# Addendum #4

Project Name:	North Greeley Sewer
Bid Number:	F24-11-096
Date:	December 9, 2024
Project Manager:	John Goin, P.E.

# EASEMENT DEDICATION FOR A PART OF SHUPE SUBDIVISION

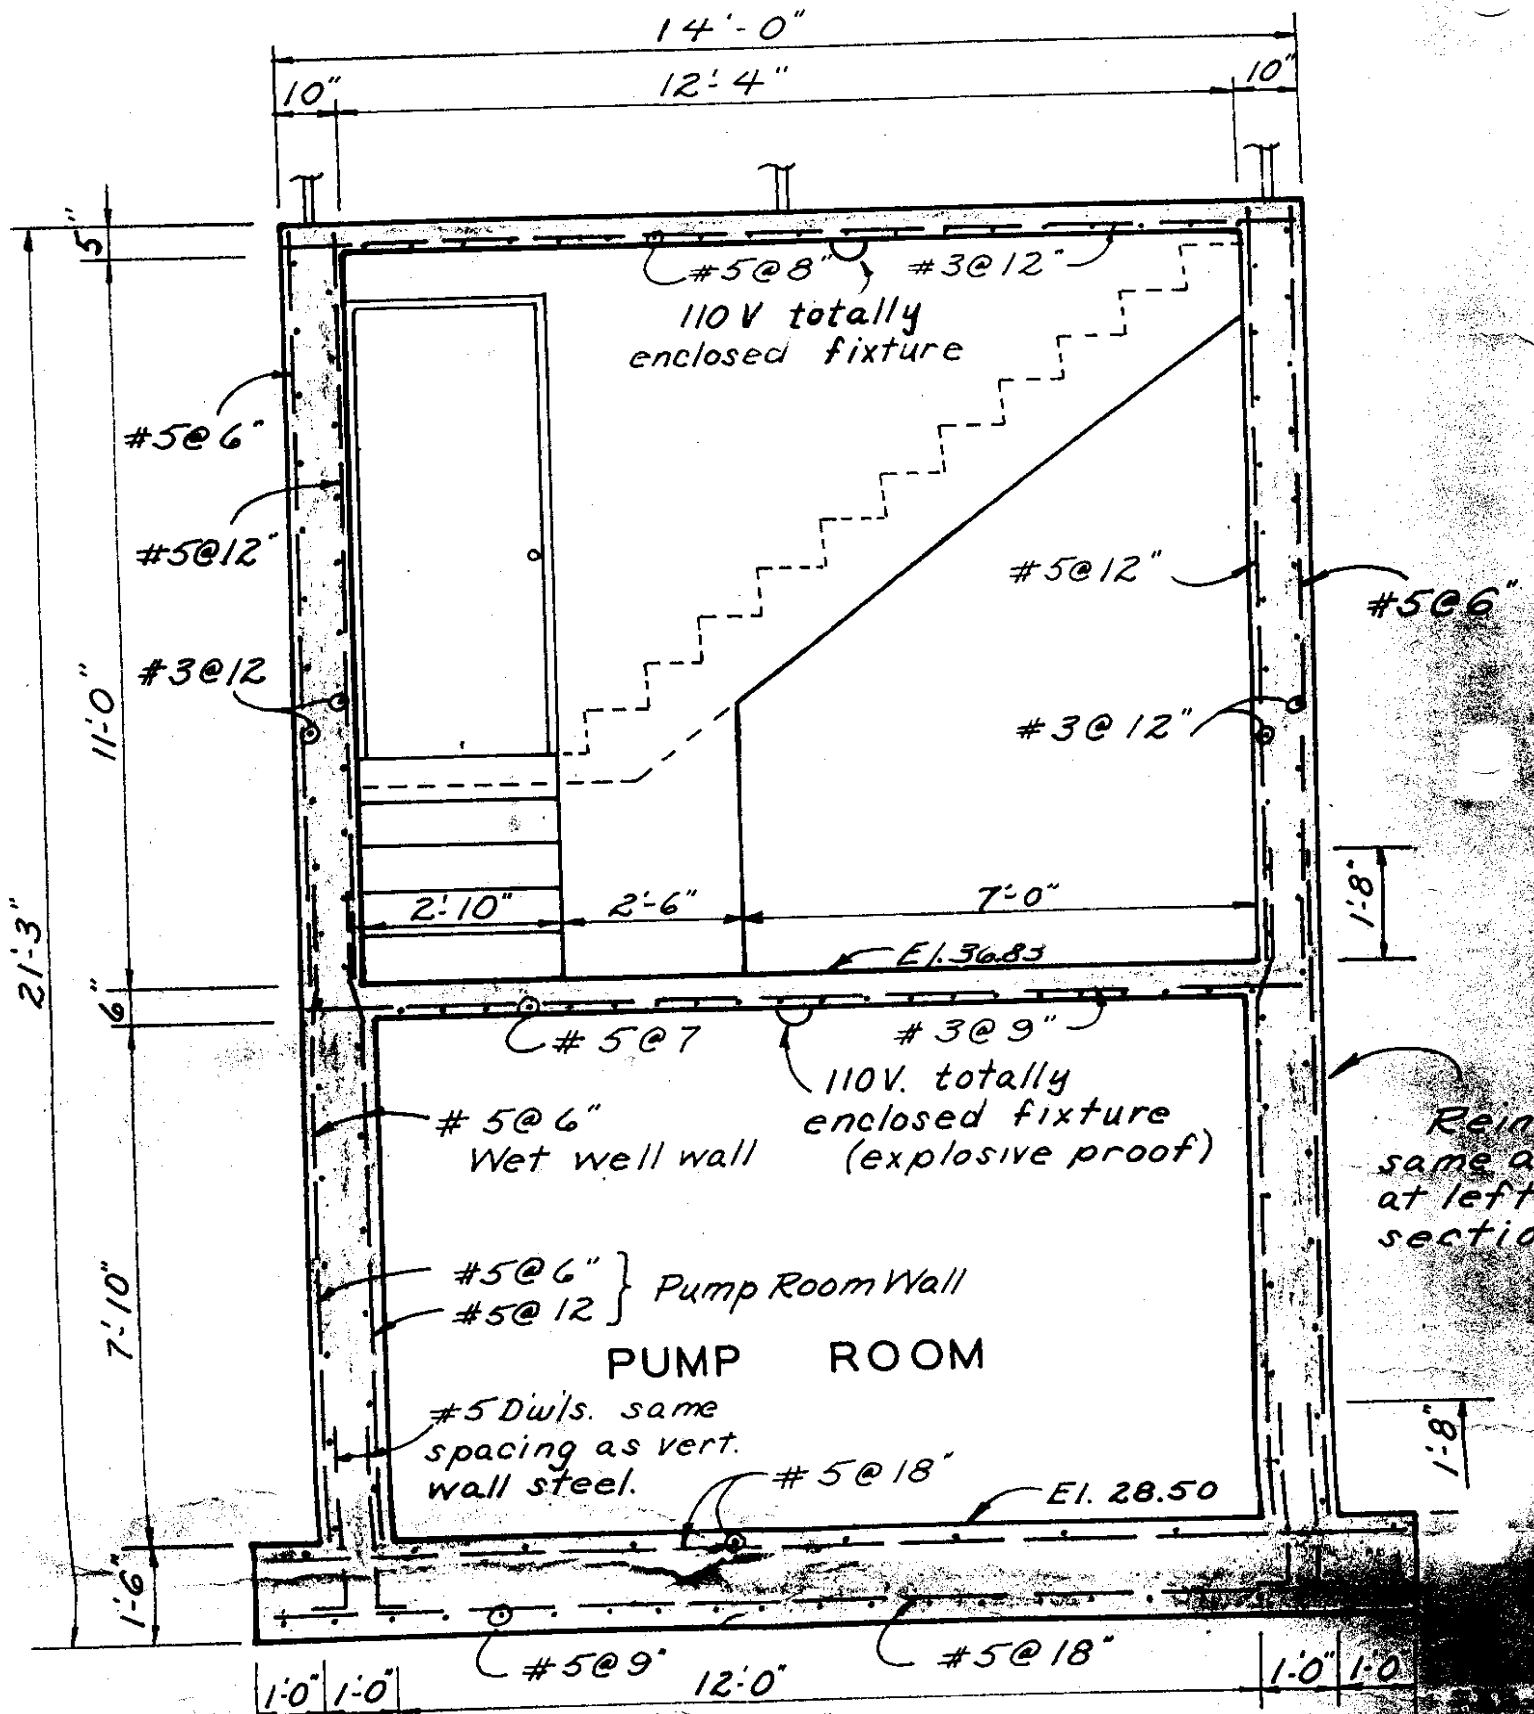
Question #1	Can the as-builts for the existing Segment 2 lift station, that is to be removed, be provided?
Answer	<a href="#">Lift Station #1 as-built information is provided with this addenda.</a>
